TCO # 002133
DATE February 06, 1984
FINAL PRODUCT MANUFACTURED BY
PLANT # 0093/0052
PLANT TCO # 1BP# 724

BULLETIN NO.: 12/16B:1

PRODUCT: 26-4004/5 (Model 12)

SUBASSEMBLY: Motorola Video Board

Figure 1

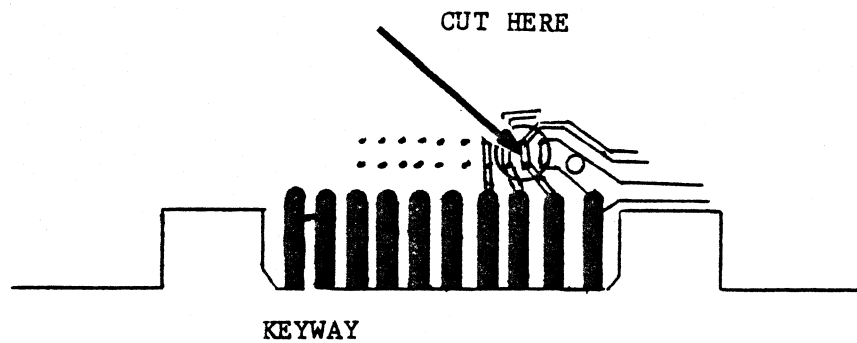
DISCUSSION: The Model 16 can use either an unmodified or modified Motorola video board, although it comes with an unmodified board. The Model 12 must use a video board that has been modified with a cut and jumper. This modification allows the video signal from the video/keyboard interface board to be routed through the video driver board on its way to the brightness control. This modification must be done to any Motorola board that is used in a Model 12.

PROCEDURE: The modification consists of a jumper that connects pin 2 of P1 to pin 5 placed in the holes closer to the edge connector as shown in figure 1. Then a cut must be made between the 2 holes in the trace that is connected to pin 2 which will disconnect pin 2 from the rest of the PC board as shown in figure 2.

Jumpers for the Main logic board for use with another computer (Direct Wire) & the ALTEST DB25 connector
Figure 2:

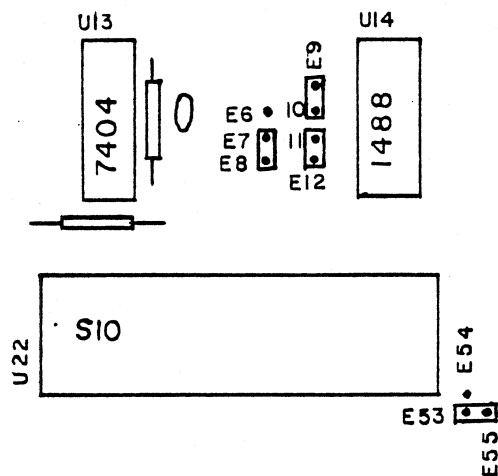
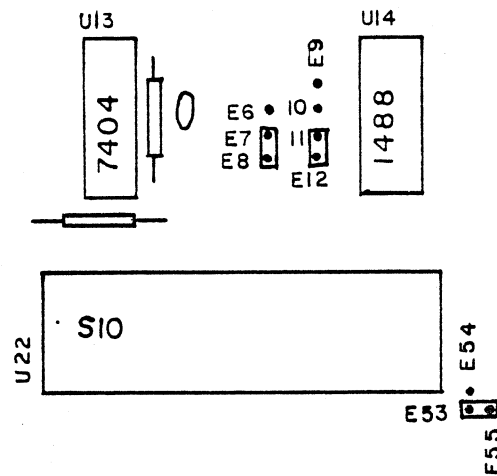
Remove jumpers E10-E11 and E53-E54 and install jumpers E53-E55, E9-E10, and E11-E12 as shown on page 4 in figure 2. You will need an additional jumper, National Parts part number AJ-6769 jumper plug. If these are not in stock wire wrap can be used instead.

If it is going to be used with a modem the main logic board should be modified as shown in figure 3 by removing E10-E9. If it is going to be wired directly to another computer it should be left as in figure 2. Also, it is recommended that the customer use a 12 conductor cable on their serial channel instead of a 25 conductor cable.

Loopback connector modifications

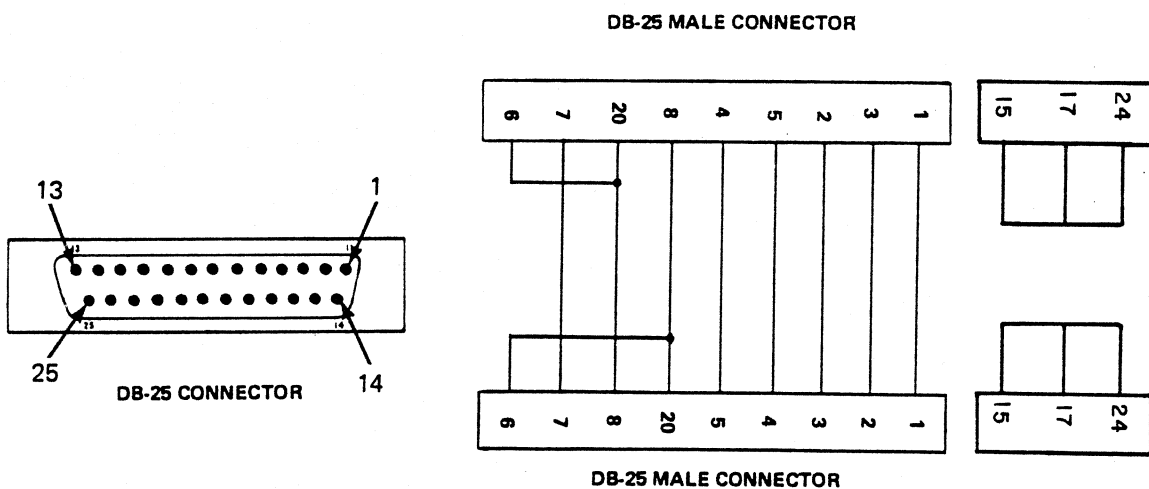
The loopback connector used with AUTO3 should be modified as shown on page 5. The connector will then be usable on both BISYNC and async computers. Run AUTO3 or the Model II family System Test on the modified computer with the modified loopback connector to verify the hardware and jumpers.

Schematic changes

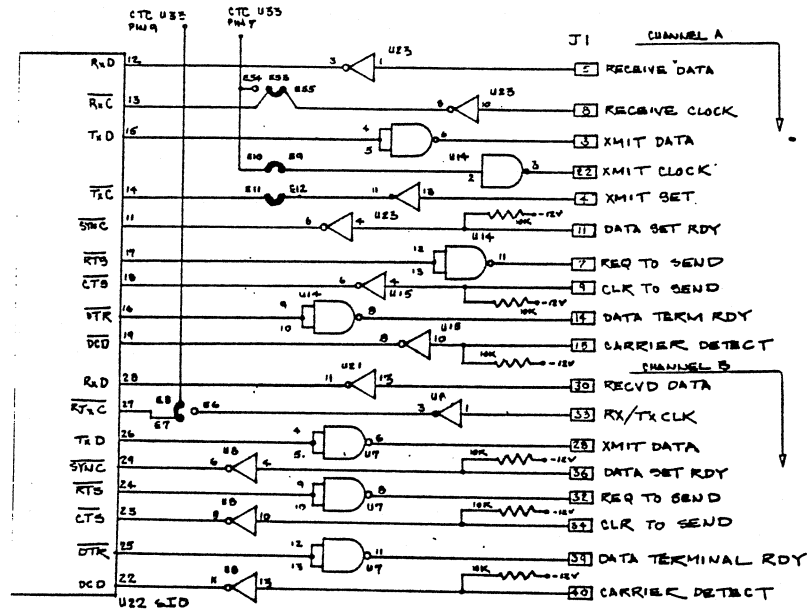
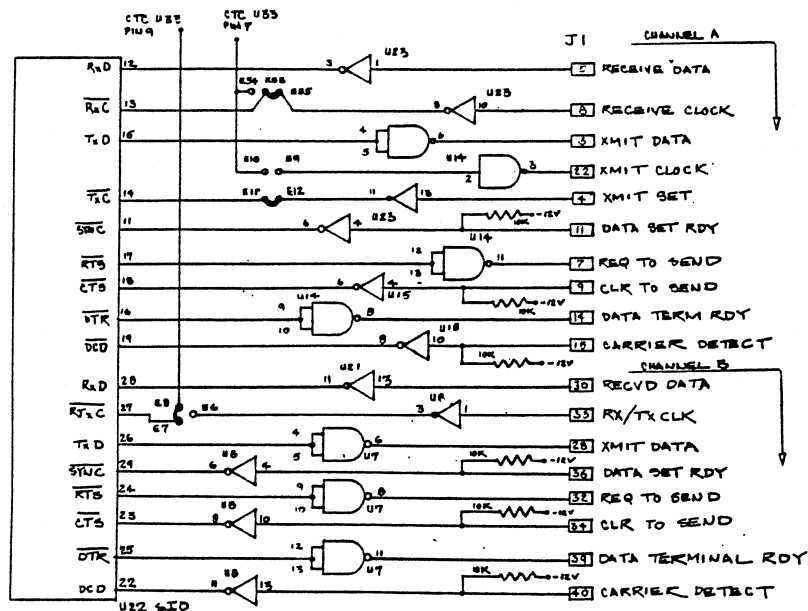
The reason for the two different modifications is that the transmit clock on channel A can cause noise problems when it is connected to the RS232 cable. When a modem is used with the computer this signal can be eliminated which reduces the noise problems. This signal is needed only when a loopback connector is used or two computers are wired directly together without modems.

Figure 1

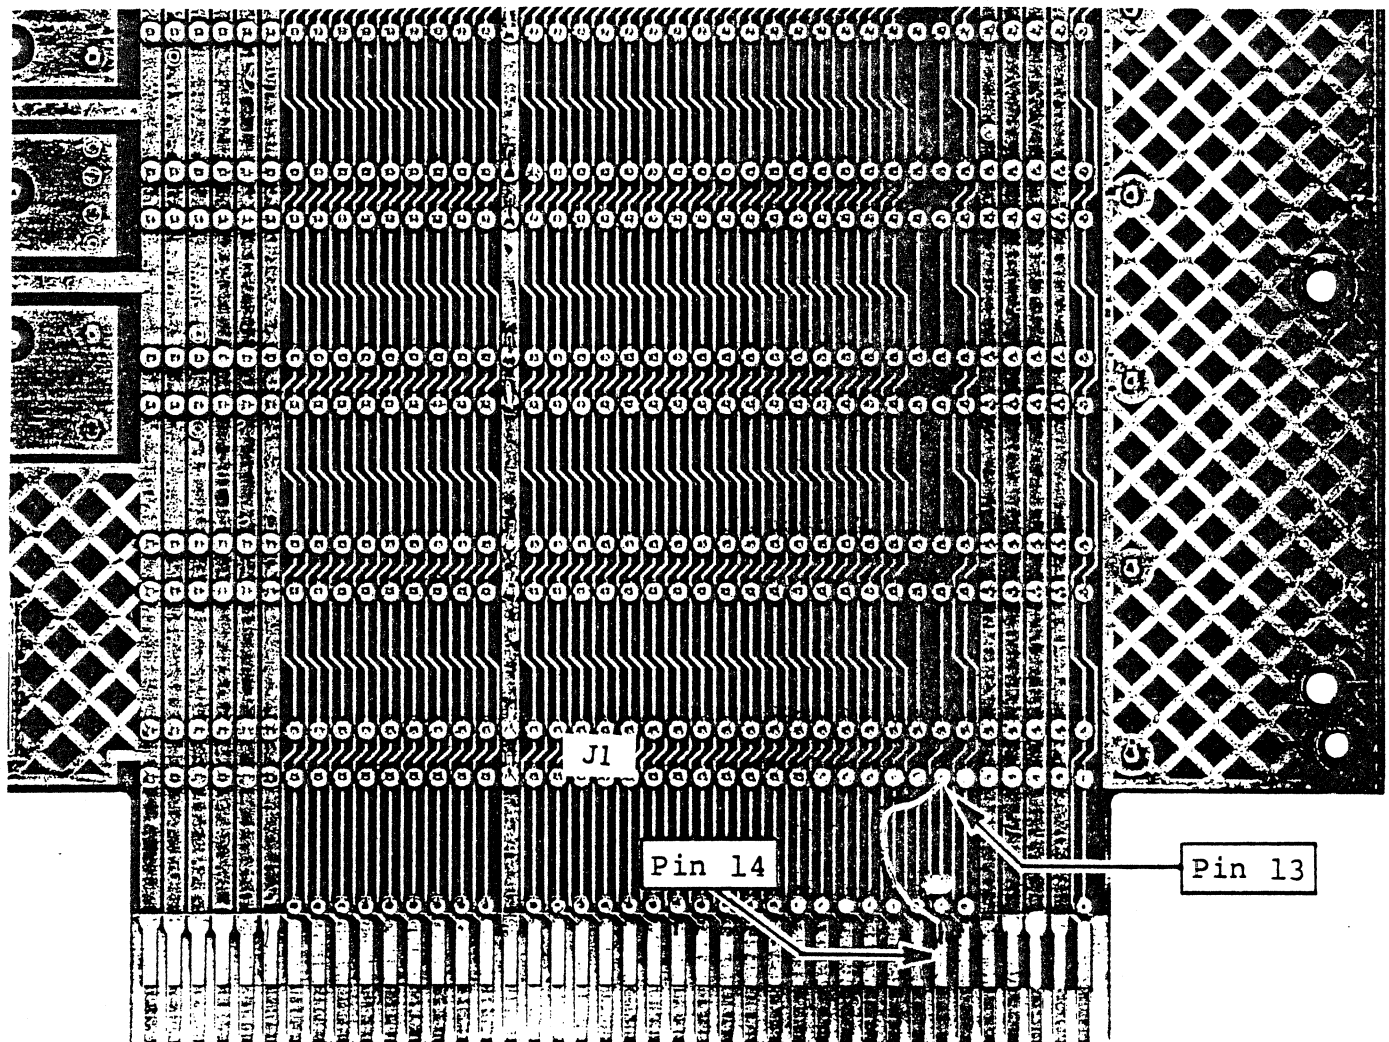
DISCUSSION: An error in the artwork of the mother board (revision PP4), will cause the 1st slot of the mother board to not function properly when a board using Z-80 family interrupts is installed.

PROCEDURE: Just above the point where the mother board plugs into the main logic board cut the two traces going to pins 13 and 14 of the plug (figure 1). Then run a jumper from pin 14 of the plug that goes into the mother board to pin 13 of the first socket in the mother board (J1).

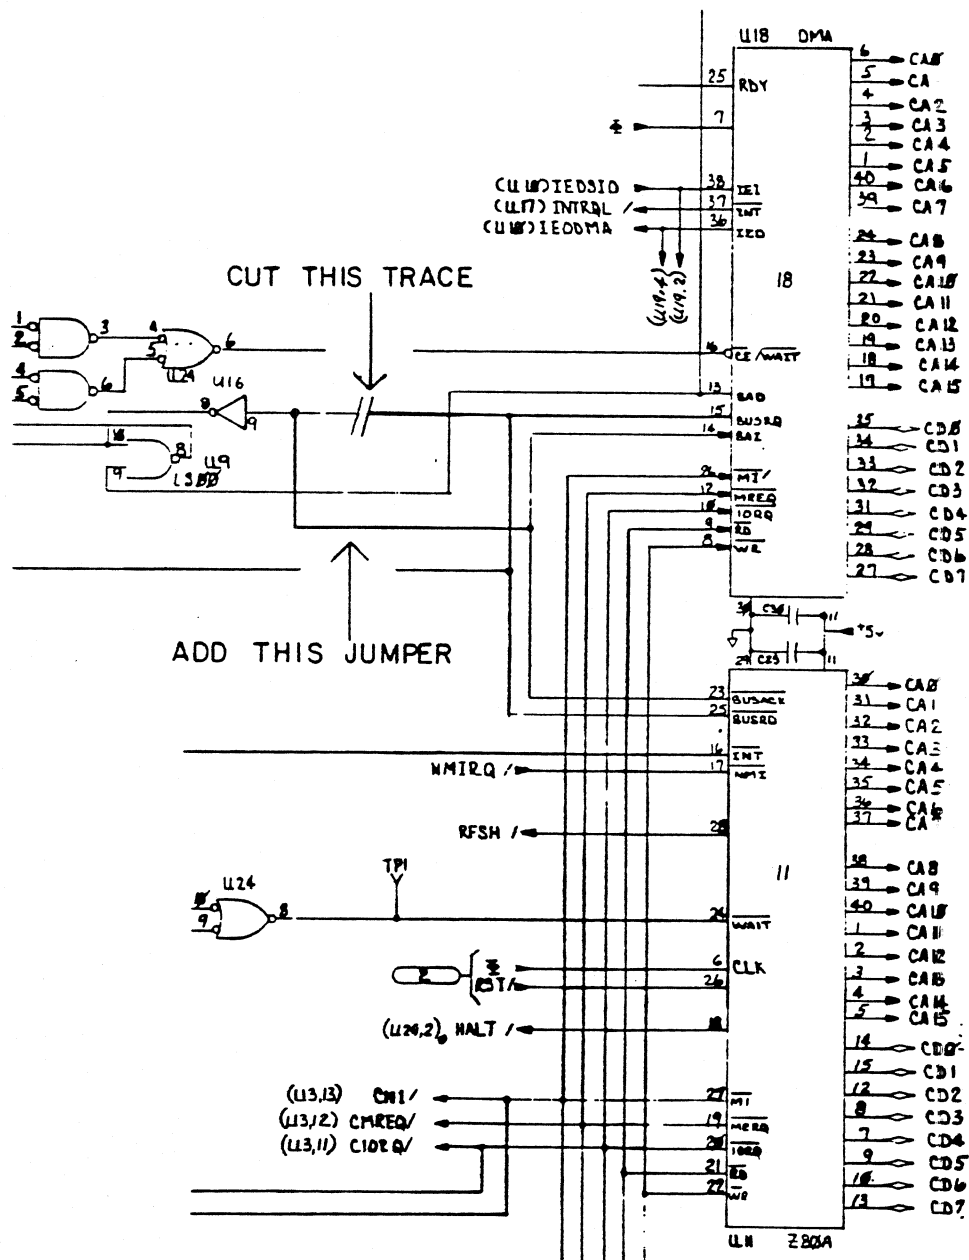
The DMA is being inadvertently selected at times causing 'garbage' to be written to the control registers. The modification described below will keep the DMA from being selected and will keep the Model 12/16B from locking up. This modification applies to all Model 12/16B's with a Rev. PP3 or Rev. Blank main logic board.

Cut the trace connected to U16, pin 9 right at the pin on the solder side of the board. Then connect a jumper from U16, pin 9 to the feedthrough connected to U11, pin 23.

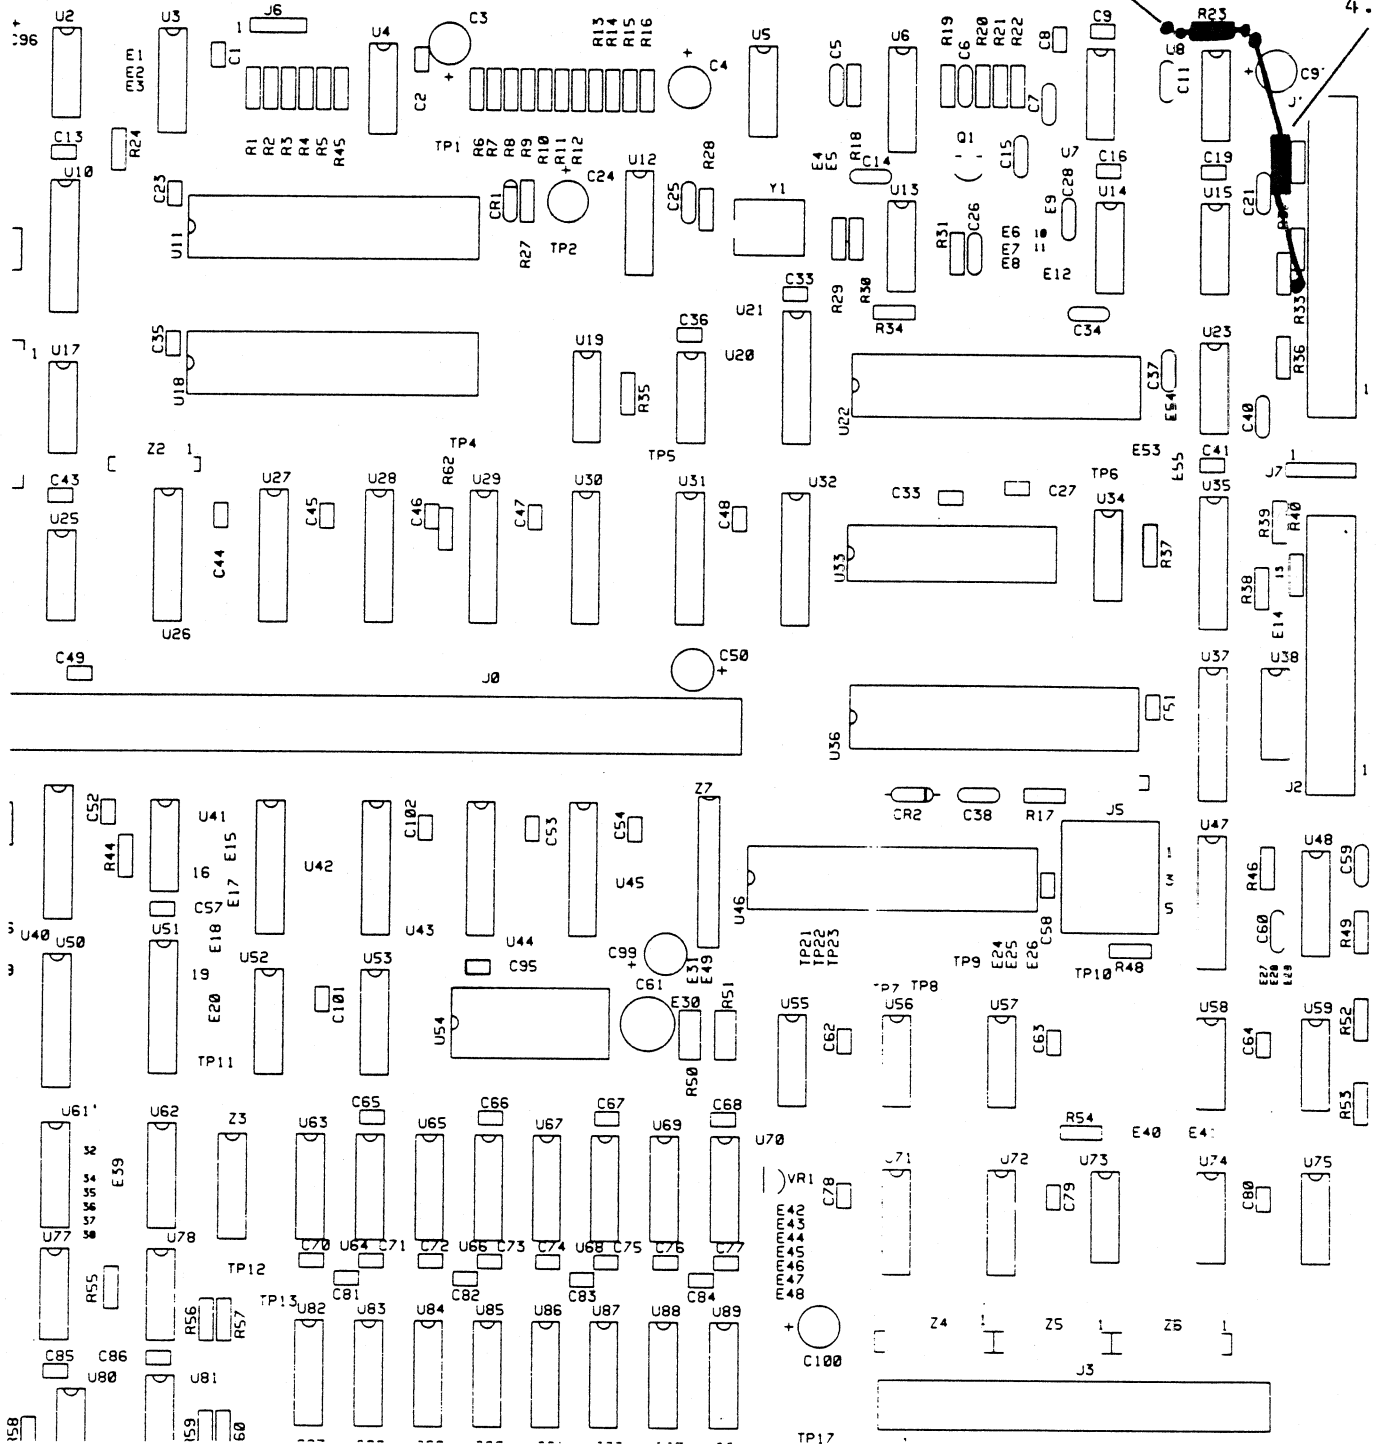
To make the serial ports more reliable the pullups for SIO control signals need to be changed. The pullup for carrier detect needs to be changed not only in value, but from -12V to +12V so that it is normally true. This modification is required on all Rev. Blank boards.

Change R21, R23, R25, R32, R36 from 10K ohm to 4.7K ohm resistors. Remove resistor R33. On the component side of the board, install a 4.7K ohm resistor with one lead attached to the old R33 solder connection closest to R36 and the other lead attached to the +12V line at the feedthrough adjacent to R23 between U8 and C97 (refer to figure 1). The leads should be insulated to prevent them from shorting.

Figure 1 Video PCB (component side)

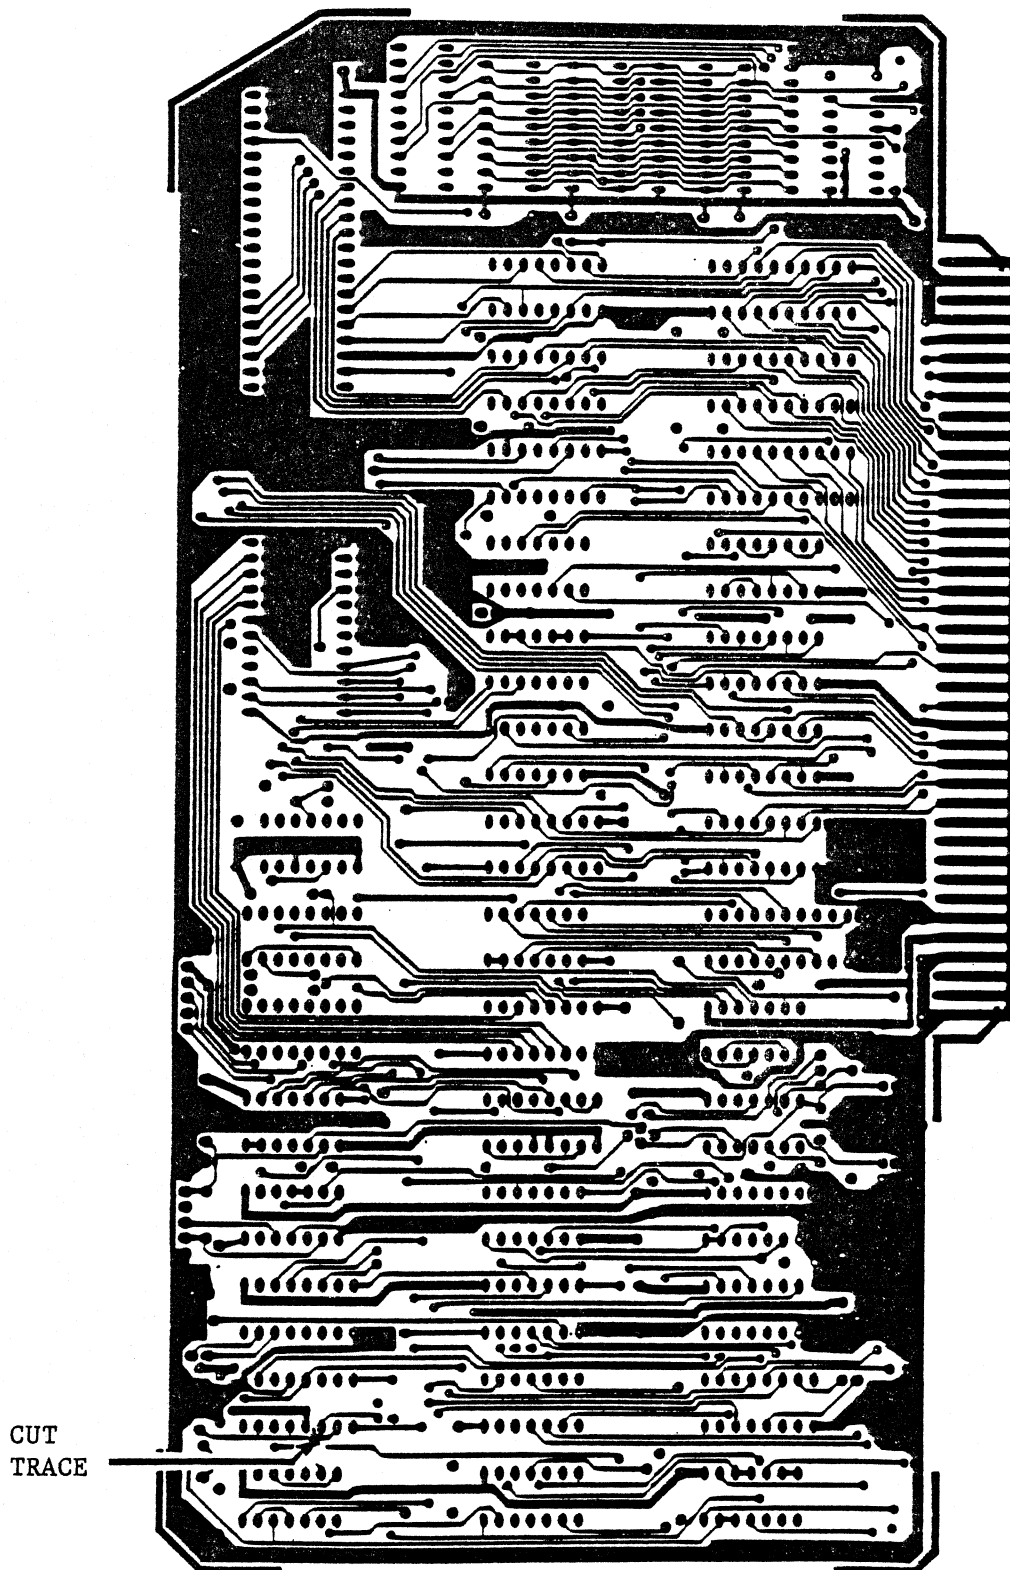
High memory addresses are shared by the Video and the 64K RAM. When the computer needs to use the video, it will activate the video RAM select logic allowing access to it. Occasionally when doing very fast RAM switching such as diagnostics, due to the access time specification of the RAM, the data transfer may not be reliable causing video failures. To correct this change the video select timing from 10ns to 100ns.

Refer to Figure 1 and cut the trace on the component side at U32 pin 7. Add a jumper wire from U32 pin 7 to U32 pin 12.

Figure 1

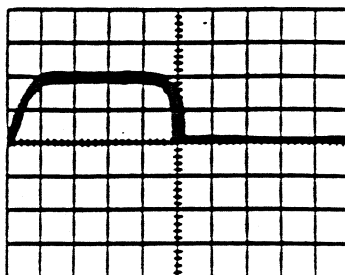
5. Connect the scope probe to TP10 and adjust R50 to attain a positive pulse-width of 200ns. Refer to Figure 1.
6. Connect the scope probe to TP8 and adjust R51 to attain a positive pulse-width of 500ns. Refer to Figure 2.
7. After these three adjustments have been done, replace jumper E30-E31 back to its original position, E31-E49.
8. Perform a system RESET then insert a Floppy Disk and proceed with diagnostic check-out.

Figure 1

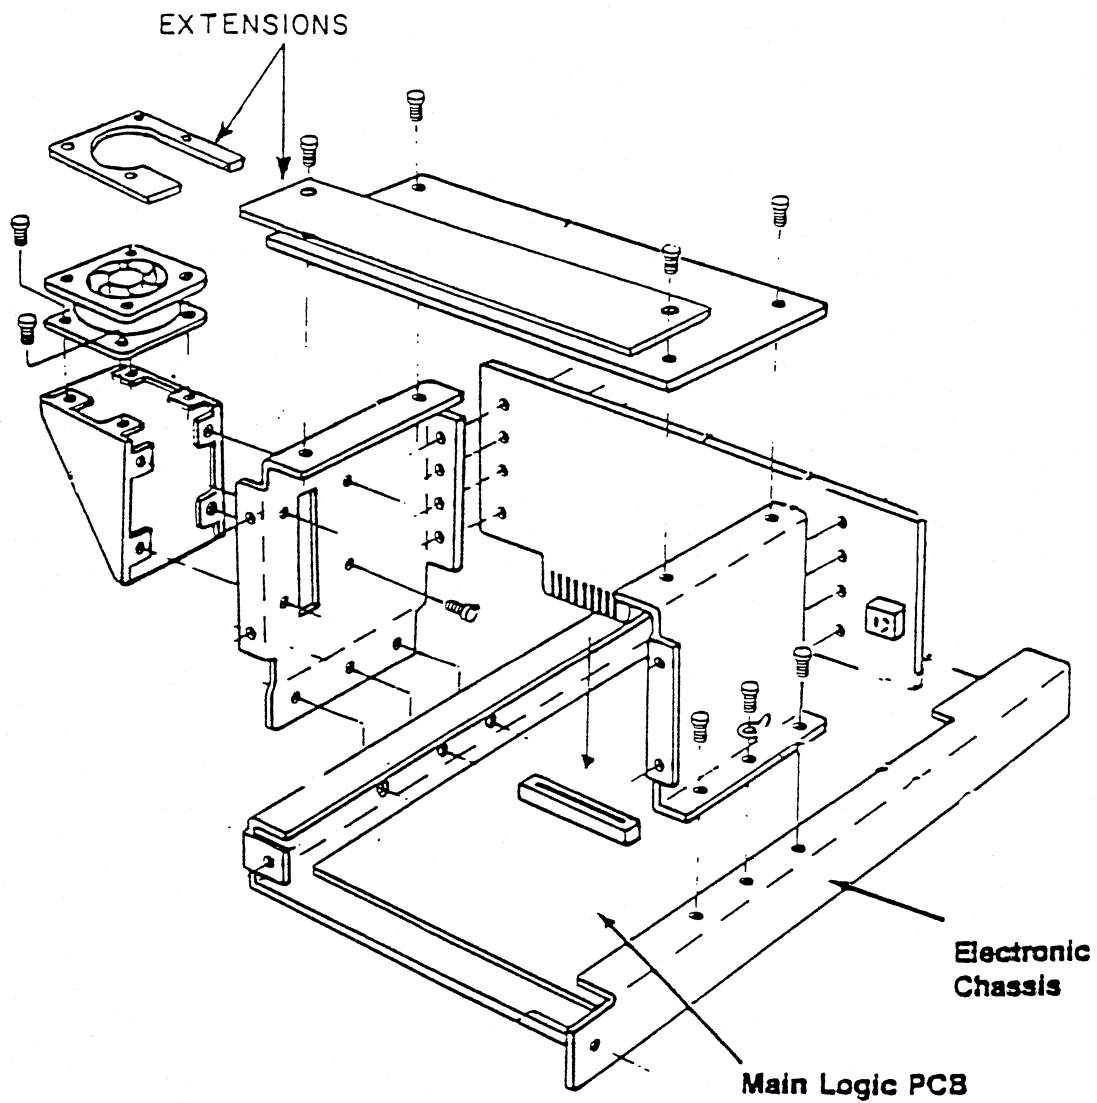
Refer to Figure 1 for the remaining steps.

2. Remove the 6 screws that hold the card cage to the chassis.
Disconnecting the motherboard power plug and the fan wires will allow the card cage assembly to be pulled up and removed.
3. Remove the top plate, fan flume, and motherboard.
4. Replace the left and right side plates with the corresponding part numbers listed above.
5. Reassemble the card cage and the computer and check for proper operation.
